Update for GMA 12 Desired Future Conditions

Presented To: POSGCD Board of Directors:

June 7, 2021

DFC Committee: Sensitivity of Number of Impacted Wells to POSGCD Carrizo Production

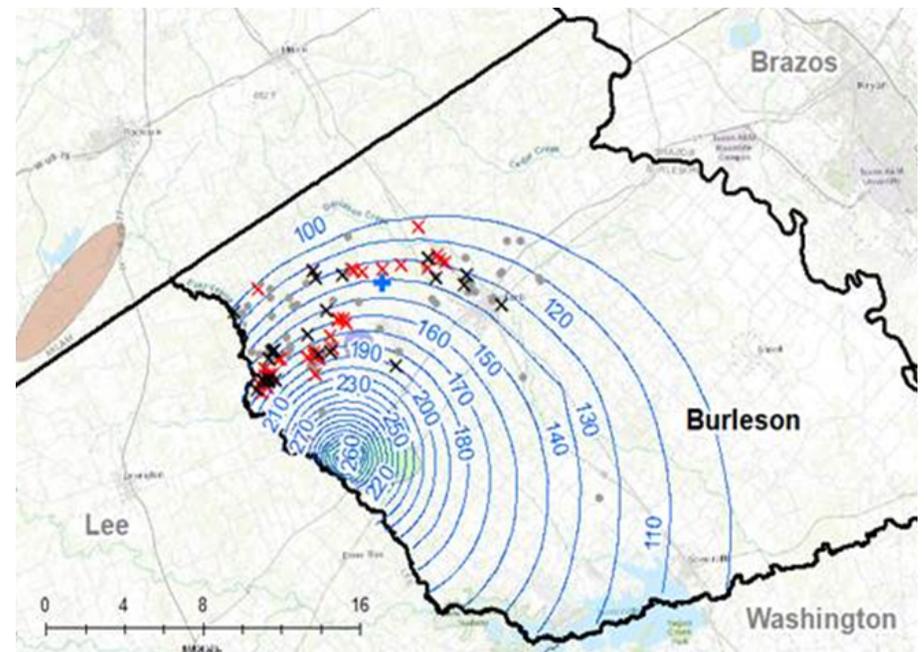
- DFC Committee

- Recommended to cap Carrizo pumping at 12,000 AFY
- Based on achieving a balance between production & impacts
- Consist with POSGCD initial estimate of ~11,200 AFY in 1st Round of Joint Planning before GMA 12 reduction
- Propose DFC for cap of 12,000 AFY is 145 ft
